**SUNDRY NOTICES AND REPORTS ON WELLS**  
*Do not use this form for proposals to drill or to re-enter an abandoned well. Use form 3160-3 (APD) for such proposals.*

8. Well Name and No.  
TIGER 6

NOI - Plug and Abandon

Re: Permanent Abandonment  
Well: Tiger 6 API: 30-045-29581

PROPOSED SCHEMATIC

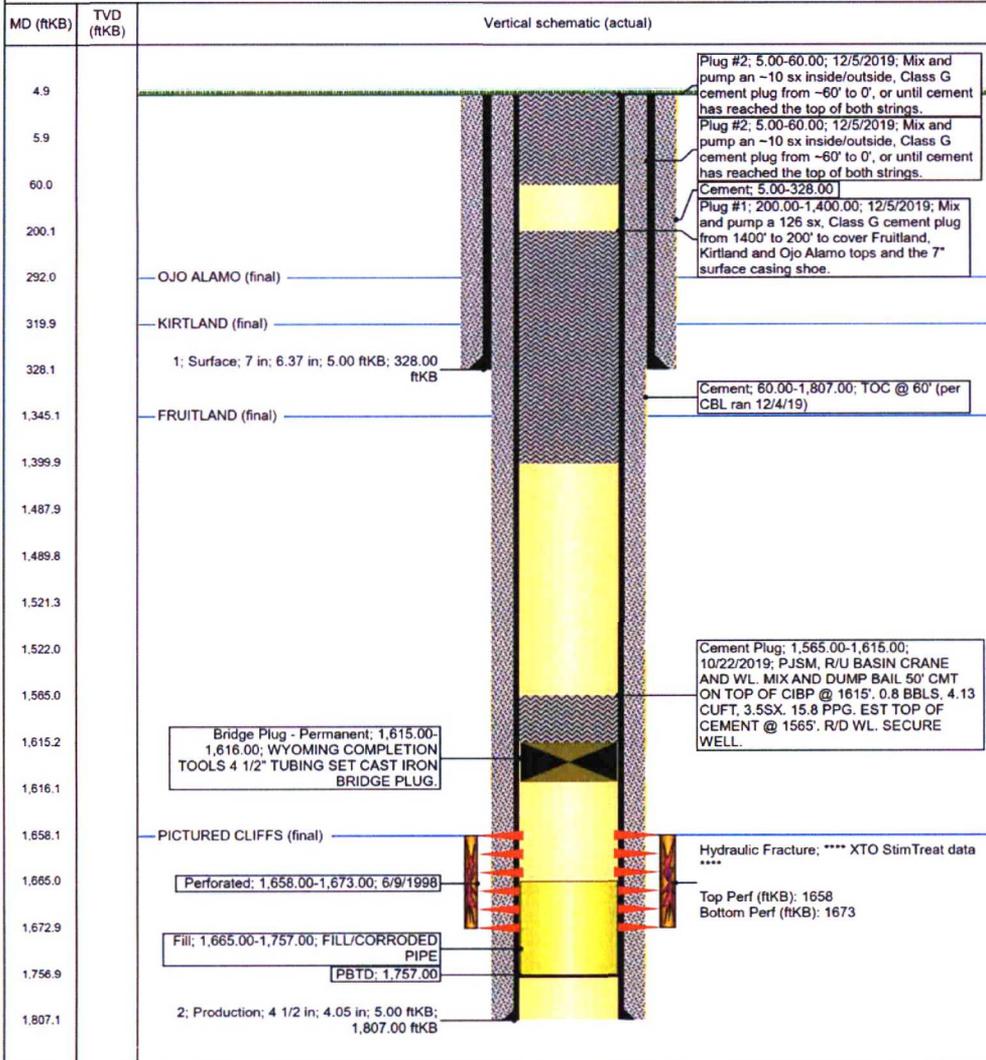
1. Plugging operations authorized are subject to the "General Requirements for Permanent Abandonment of Wells on Federal and Indian Lease."
2. Forward CBL to Joe Killins [jkillins@blm.gov](mailto:jkillins@blm.gov), John Hoffman [jhoffman@blm.gov](mailto:jhoffman@blm.gov) and Brandon Powell [brandon.powell@state.nm.us](mailto:brandon.powell@state.nm.us).
3. Farmington Office is to be notified at least 24 hours before the plugging operations commence (505) 564-7750.
4. BLM picks formation tops as indicated in Geo Report attachment for use in determining TOC for all plugs. Please adjust plugs according to BLM tops.
5. Surface plug: perforate and circulate cement.

- BLM geologist's pick for the top of the Ojo Alamo, Kirtland, Fruitland, and Pictured Cliffs formations varies from operator's.
- Log analysis of reference well #2 (attached worksheet) indicates the Ojo Alamo sands investigated contain fresh water ( $\leq 5,000$  ppm TDS).
- Please ensure that the tops of the Pictured Cliffs, Fruitland, and Kirtland Formations, as well as the entire Ojo Alamo fresh water aquifer identified in this report are isolated by proper placement of cement plugs. This will protect the fresh water sands in this well bore.
